**AGENDA
CANBY PLANNING COMMISSION
REGULAR MEETING
City Council Chambers
November 19, 1990 - 7:30 p.m.**

- S T A F F R E P O R T -

- S T A F F R E P O R T -

- M E M O -

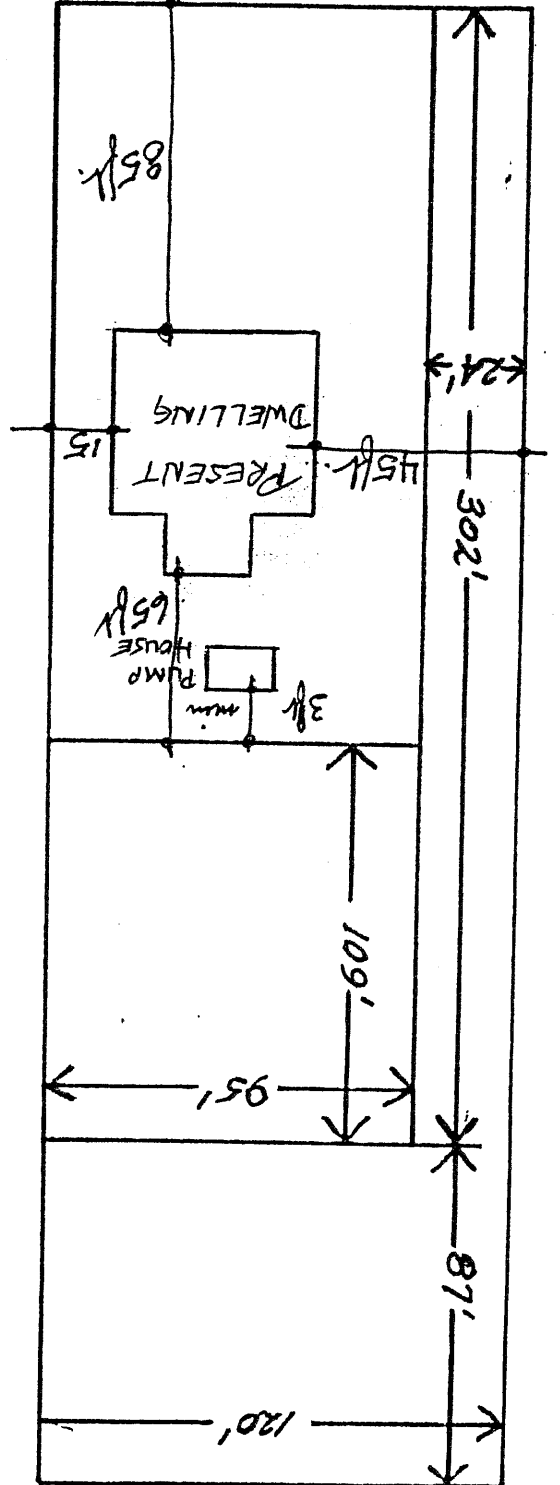
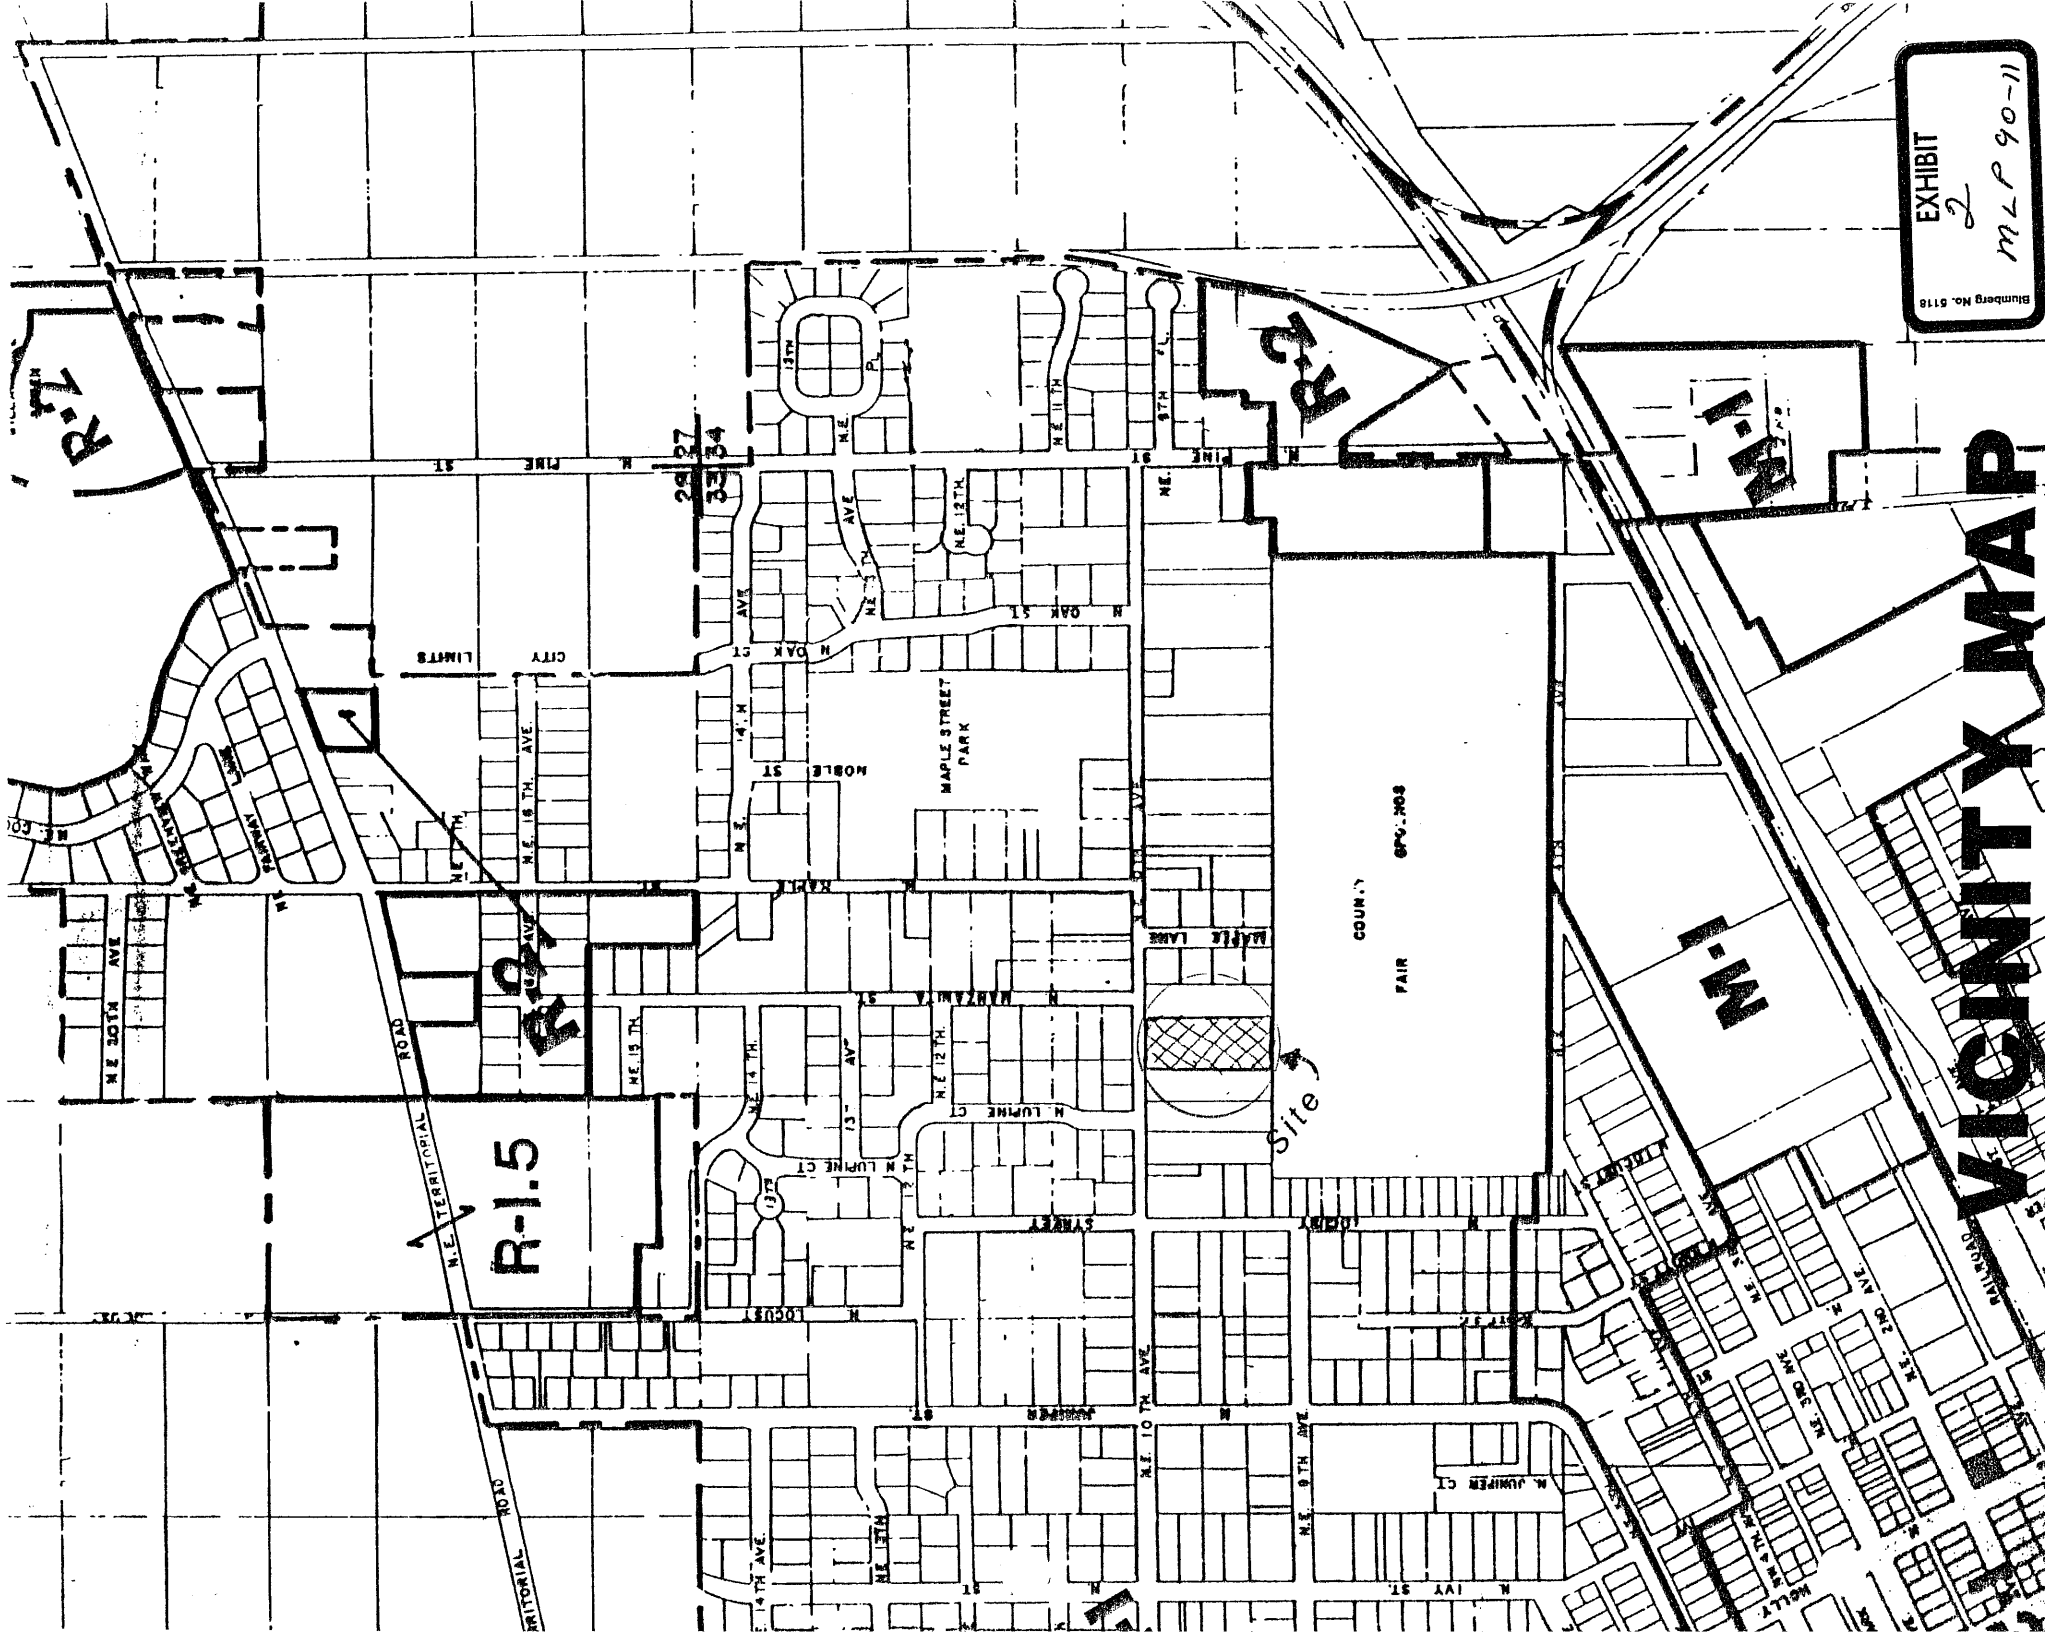
Canby's ordinance requires that any newly created parcels have access to a public street. The three parcels will have access to N.E. 10th Avenue by way of a common easement of wider than required width. Sidewalks are not present on the entire frontage. N.E. 10th is an existing collector in the Comprehensive Plan. It is currently a 40 foot right-of-way and the standard for a collector street such as 10th Avenue is 50 feet. Ten feet of right-of-way should be dedicated.

The partition, as proposed, will result in the creation of three rectangular lots consisting of approximately 10,440, 10,355 and 18,000 square feet, respectively. The applicant will be required to provide any necessary easements for utilities as a standard condition of approval. An access easement of over 24 feet in width is proposed to serve the rear two flag lots.

The subject property is generally flat with adequate room for building and required setbacks and yards. The parcel is zoned R-1, Low Density Residential, and each parcel is large enough to provide adequate development space and yards. A minimum of a three foot rear yard needs to be provided behind the "pump house."

Plat maps indicate that the access to two flag lots behind the same residence will be adequate to serve both dwellings, provided that a reciprocal agreement is recorded. Turnarounds will be adequate on each building site without necessitating backing onto the access driveway itself. No access is available from the east or west due to private properties, nor from the south, where Clackamas Count Fairgrounds adjoin petitioner's property. Placing two additional single-

3. Utility easements 12 feet in width shall be provided on the exterior of the proposed development and six feet on all other property lines, and shall be part of the final partition.

8. A sidewalk and new pavement of the street area between curb and current street pavement shall be provided prior to building permits being issued for the flag lots.

9. A reciprocal agreement to share the driveway shall be made a part of the final partition.
10. A strip of land 10 feet wide shall be dedicated for eventual widening of N.E. 10th Avenue to collector street standards.

EXHIBIT
2
SUB 90-05

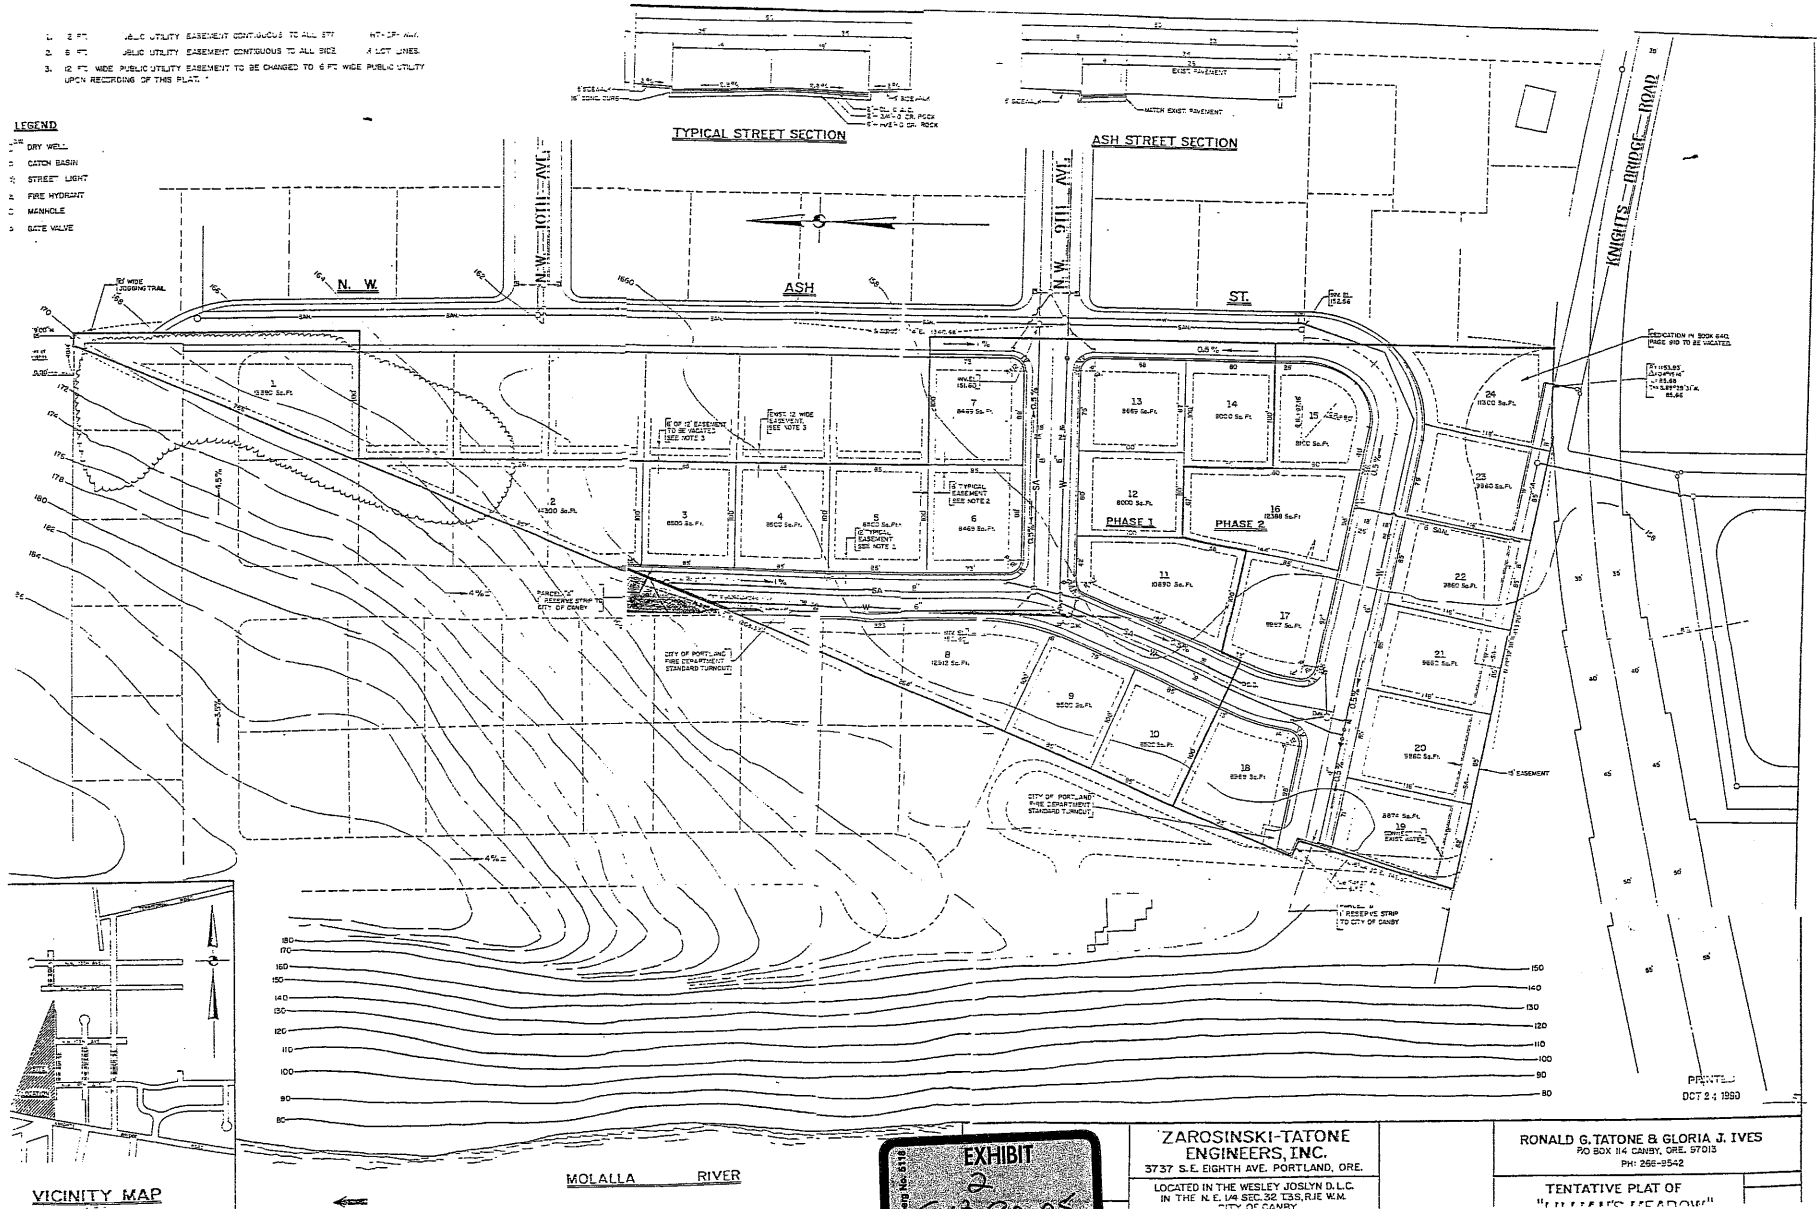
Since the site is a triangular shape, some creativity and ingenuity are necessary to solve some of the problem areas. The site plan illustrates how the adjacent parcel to the west could be developed and still be related to the subject development in terms of streets, utilities and lot layout to be compatible with this design. There are a few awkward situations which the applicant proposes to solve through deed restrictions. These are as follows: Lots 1, 2 and 8 are to be oversized lots. The house location is proposed to be specified in the CC&Rs so that area within the lot, that lies within the narrow "acute angle" end of the lot, can eventually be combined with adjacent land. This would be done in order to form more regular lots at a later time. Lot 2 is proposed with only 25 feet of frontage on a street and the street end is designed at an extremely acute

angle. The applicant must show how a driveway could work in this situation or **lot lines will need to be adjusted to provide a safe driveway** to Lot 2. The current access drive, from Knights Bridge Road to the two existing homes near the Molalla River, is to be replaced by access from the new streets and/or by a 15 foot easement located at the rear of Lots 19-24. The applicant reports that the existing access road off Knights Bridge Road exists on his property, but he proposes to leave an easement to continue this access. The County reports that this is a County street with a turnaround. The applicant will need to resolve this matter. Otherwise, the lots are designed to meet City standards and are all larger than the required 7,000 square feet.

Blocks - Generally, the block designs, sizes, topography, lengths, and shapes are well suited to the site and provide an adequate framework for lot design. The exceptional situations needing further resolution are the "acute angle" lot structures such as Lots 1 and 2.

Lots (Section 16.64.040) - In most cases, lots have been designed to meet standard subdivision practices and are appropriate for the difficult triangular site. Lots 1 and 2 need further work to resolve the difficulties.

1. Certain conditions of approval are adopted, and
2. The driveway access issue to Lot 2 is resolved, turnaround is provided, driveway off Knights Bridge Road (extended), and signage is provided.

1. Temporary turnarounds, meeting the requirements of the Fire Marshal and Director of Public Works, shall be provided at the ends of the streets that will continue at a later time. A full-width barricade shall be placed, at the developer's expense, at the end of the new streets.
2. N.W. Ash Street shall be constructed 50 feet in width throughout the subdivision, with a 36 foot pavement over its entire length, including the northern end.
3. Any necessary utilities shall be constructed to the specifications of the provider.
4. Utility easements shall be provided and are to be twelve (12) feet along all streets. Exterior lines of the subdivision adjacent to other platted subdivisions with easements, and easements along all interior lot lines, are to be six (6) feet wide off of each lot, for a total of twelve (12) feet.

5. Street name and traffic control signs shall be provided at the developer's expense. This shall include "dead end" signs for the ends of Ash and the new streets, "No Right Turn" signs at the southwest corner of 10th and Aspen and 9th and Aspen, and a "Private Drive" sign at the end of the street in the southwest corner.
